Appl. No. 09/807,225  
Amdt. Dated July 15, 2004  
Reply to Office action of May 18, 2004

**Amendments to the Drawings:**

Replacement Sheet  
 Serial No.: 09/807,225  
 Filed: April 9, 2001  
 Conf. No.: 2717  
 Atty. Docket No.: 33475  
 Sheet 1 of 1

# PRIOR ART FIG. 13

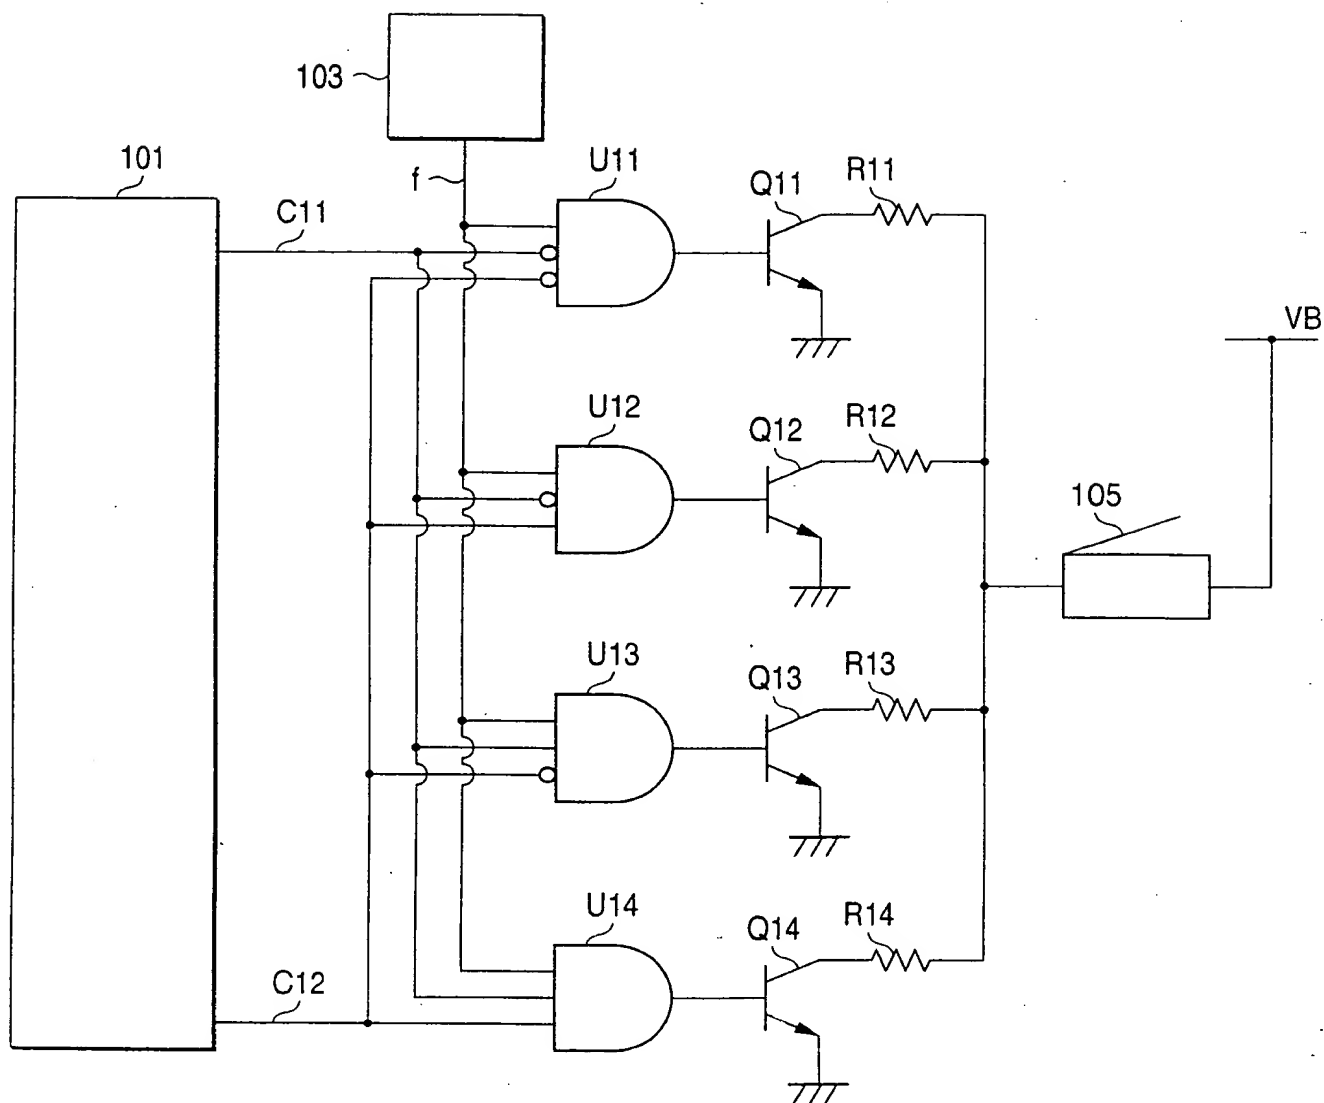
The attached sheet of drawings includes changes to Fig. 13. This sheet, which includes Figs. 13 and 14, replaces the original sheet including Figs. 13 and 14. Fig. 13 has been designated as being "Prior Art".
